# TOWN OF GLASTONBURY

GL-2023-12

## FIRE HOUSE IMPROVEMENTS

ADDENDUM NO. 4

**LOCKER ROOMS PART PLAN - LIGHTING**  
SCALE: 1/4"-1'-0"

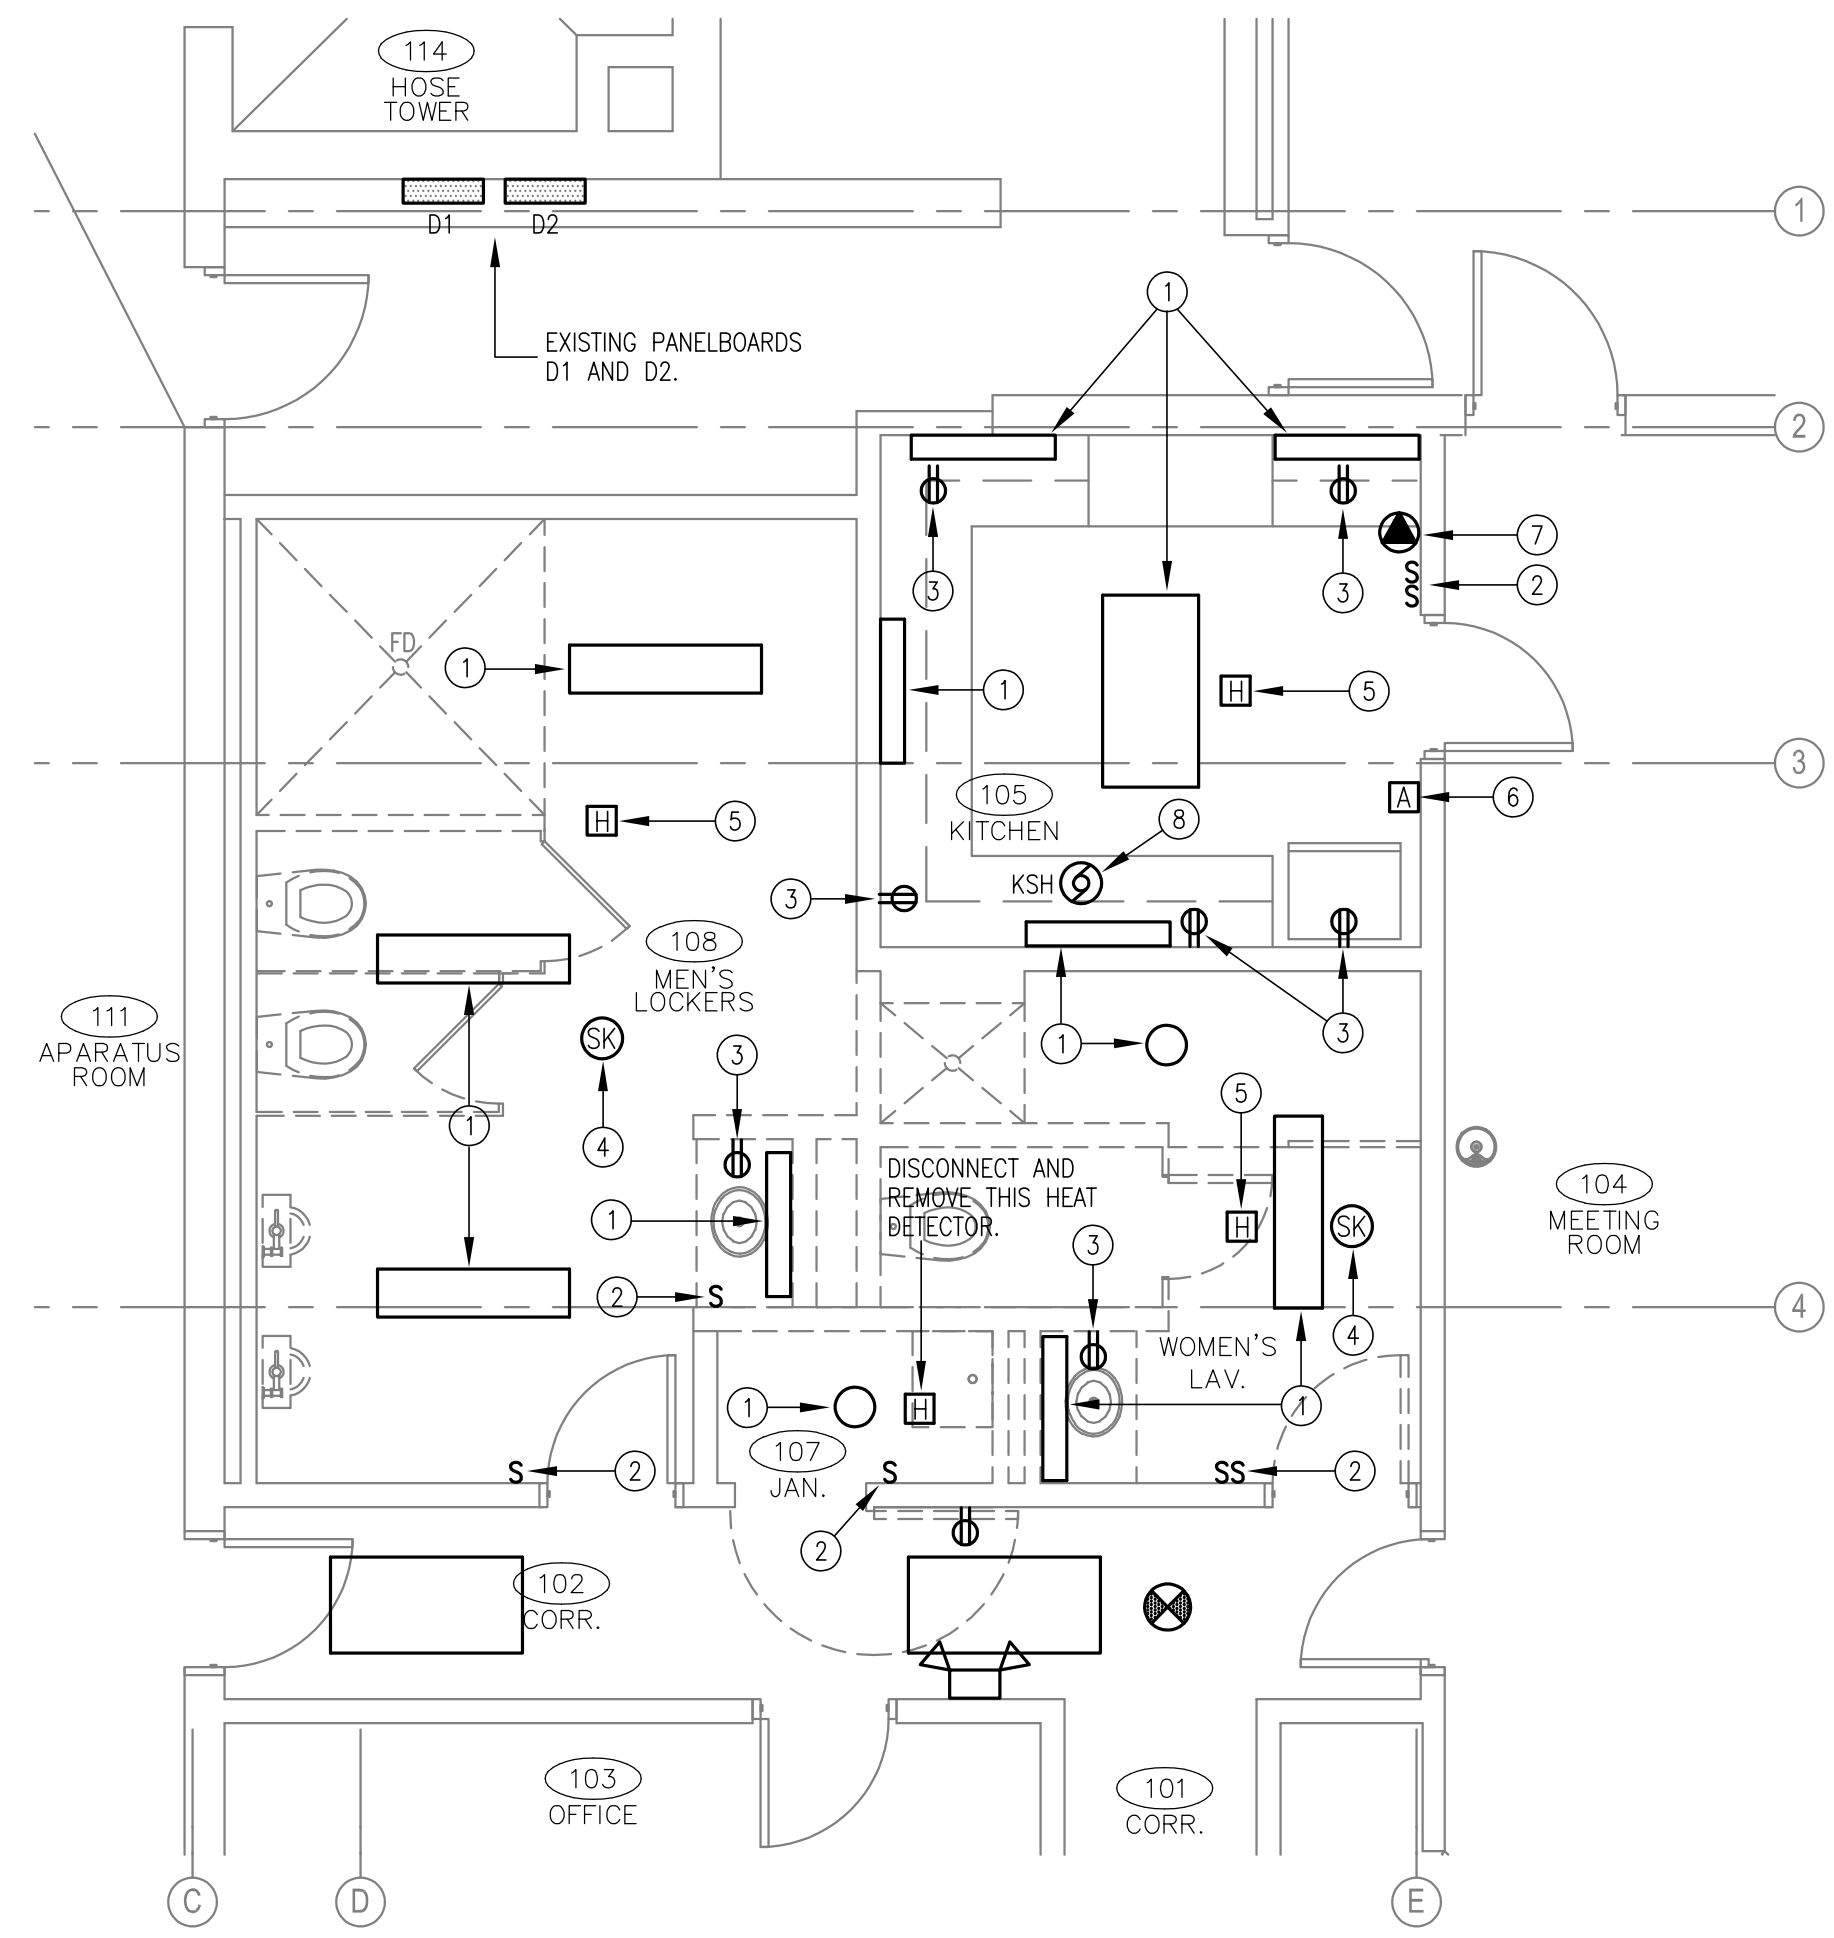
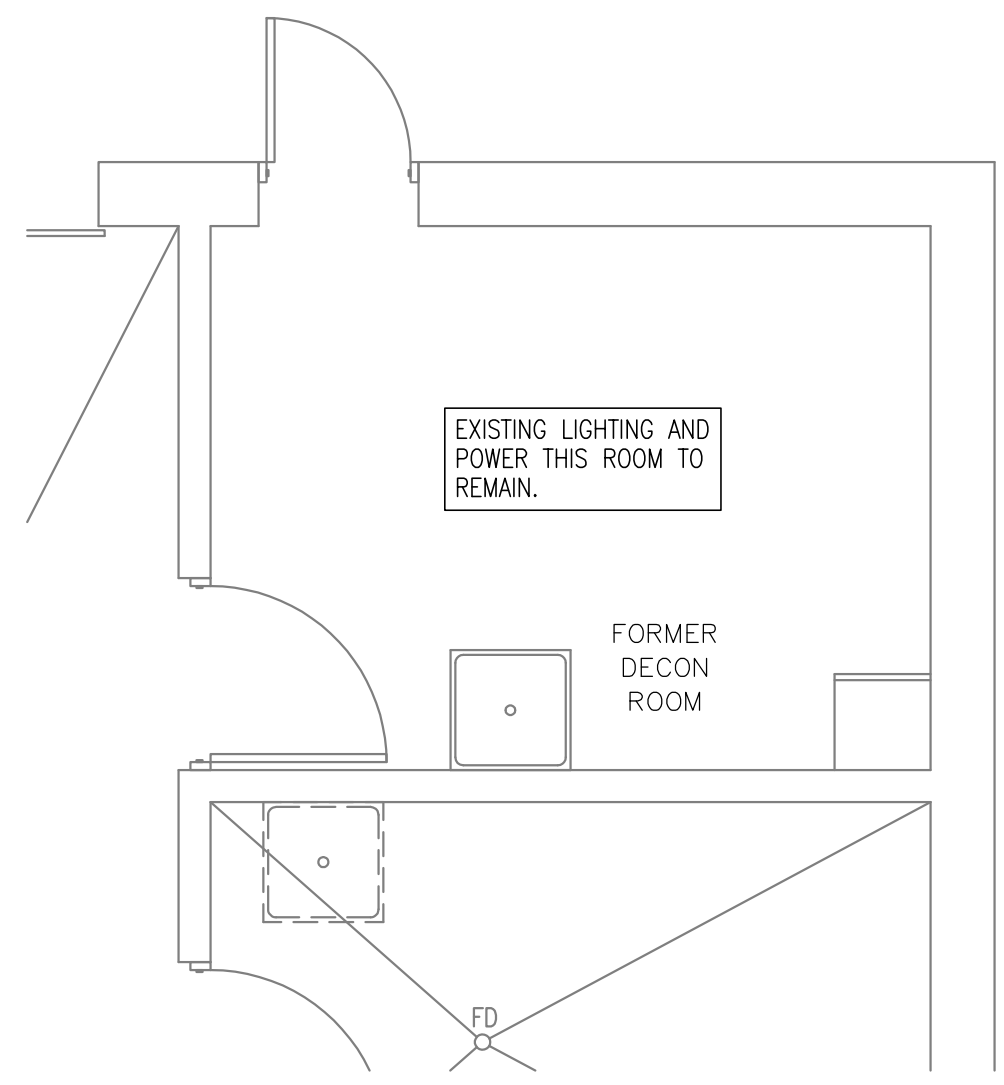
**Question 7:** *Please clearly define the extent of the electrical work the contractor is responsible for.*

**Question 23:** *Can you provide a power plan for this project or is the electrician to engineer the build?*

**Question 24:** *Can you provide detailed photos of the existing electrical distribution system (IE electrical panels, metering equipment, MDP)*

**Question 39:** *How many lights are being removed during demo?*

**Question 42:** *In reference to addendum 3, Question 10 – Are the occupancy sensors to be wall mounted type or pad mounted in the ceiling?*

**Question 46:** *Three “surface mounted heating units” are indicated on the drawings. Are these hydronic or electric? If electric, are they owner supplied/EC to install, or EC to supply and install? Please provide part number (or basis of design), and circuiting requirements for each heater.*

**Answer:** See Drawing E1

**Answer:** See Drawing E1

**Answer:** See Drawing E1, verify in field

**Answer:** See Drawing E1

**Answer:** See Drawing E1

**Answer:** See Drawings E1, M1
